Interactive comment on “Sub catchment Assessment of snowpack and snowmelt change by analyzing elevation bands and parameter sensitivity in the high Himalayas” by Vishal Singh et al.

Received and published: 4 May 2017

Fig. 2 (a): Scatter plots of daily calibration (1991-2000) and validation (2001-2008) at three outlets: (a) Rampur calibration, (b) Rampur validation, (c) Suni calibration, (d) Suni validation, (e) Kasol calibration, (f) Kasol validation.

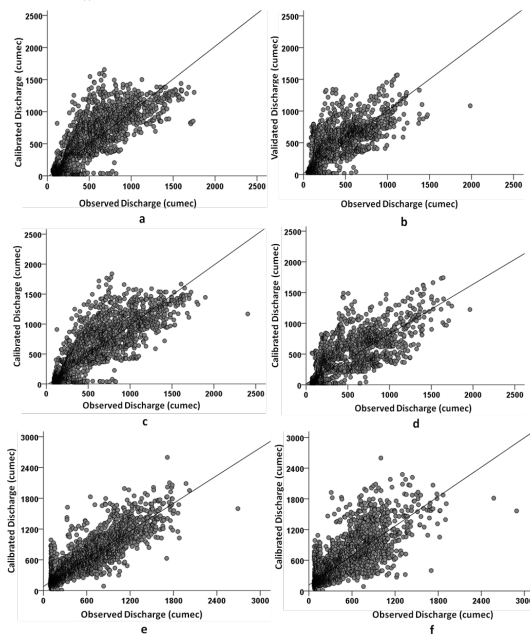
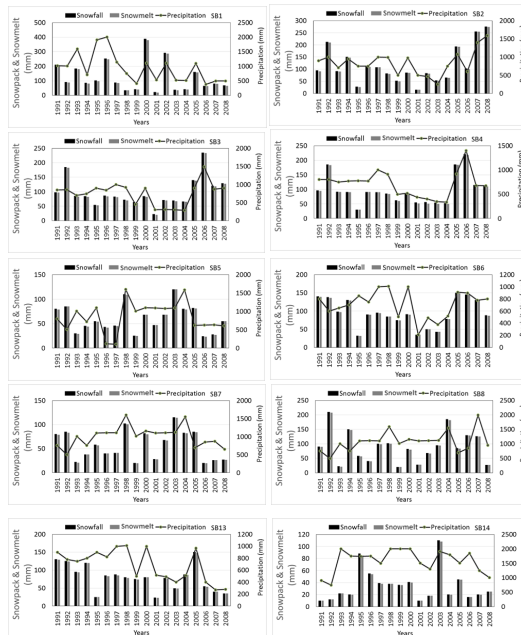
3- “. . . attempt to improve uncertainty propagation of these huge uncertainties in the input data.”

Figure 2: Please correct the spelling of “snowmelt” in each graph. Please define what you mean by snowpack and snowmelt. Is snowpack the depth of the snowpack and snowmelt the snow water equivalent? Corrected. Snowpack (depth). Figure 4: The figure caption for this figure does not make sense. Graph (b) does not seem to show the cumulative variability in snowpack amount as stated in the caption.

We enhance the representation of the model performance in the calibration and validation stages. Table 4 was improved and Figure 2 developed to show these key aspects of modeling hydrologic processes.

Changed.

Fig. 6. Changes and inter annual comparisons in average annual (a) precipitation, (b) snowpack/snowfall, (c) snowmelt, (d) water yield (due to snow) and (e) total water yield (snowmelt and rainfall runoff) over the study area in different temporal climate domains (1991-2030).

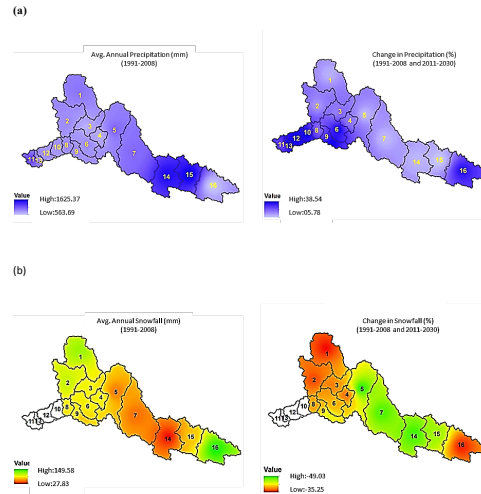
Figure 6: This figure is somewhat awkward. The labels for each plot are too big and cover in some instances the map. I would suggest putting each map into a grid/frame that is then clearly labeled with both a-j and the thematic title of the map.

Grid frame will reduce the spatial variations because at smaller scale the resolution of the figures will be distorted. The grid is not needed as their extent coordinate values we have already explained in the text (study area section). The captions are needed to explain each figure.

Fig. 7. Percentage of change in snowpack amount (average annual) over different sub-catchments of Satluj river.

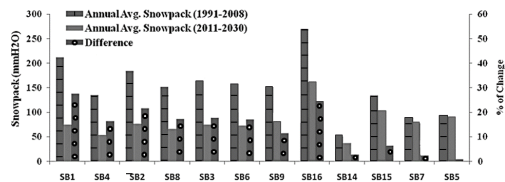
Line 397: How would a change in elevation bands influence the results shown in Figure 7? Explained.

Fig. 7: Why are the bar graphs not sorted in increasing order from SB1-SB16 along the x-axis? SB5 is the last bar with the least change in snowpack but it is not clear what elevation band this sub-catchment belongs to. We considered that the current order reflects the geographical context rather than the numerical values assigned to each sub-catchment.

[Figure 7 illustrates the magnitude of change (shown as “% of change”) in snowpack amount as a function of the fraction of elevation bands. At each sub-catchment, the snowpack differences have been computed and analyzed by comparing historical and near term scenarios. The results showed significant decrease in snowpack amount across all the snowpack-dominated sub-catchments. A 5% (minimum) to 42% (maximum) decrease in snowpack has been accounted across all the sub-catchments. This contributes to evidence increasing temperatures in snow cover and glacier melting over Himalayan catchments. The sub-catchments SB1, SB2, SB3, SB8 and SB16 correspond with the utmost decrease in snowpack amount (20% to 42%); whereas, the sub-catchments SB5, SB7, SB14 and SB15 SB16 showed a small to moderate decrease in snowpack amount (4% to 20%). Also, SBs, situated at high elevation areas showed larger changes or decreases in snowpack with respect to the moderate-elevation SBs. This illustrates a conspicuous warming trend at high elevation portions with respect to those at moderate and low elevation ranges.]
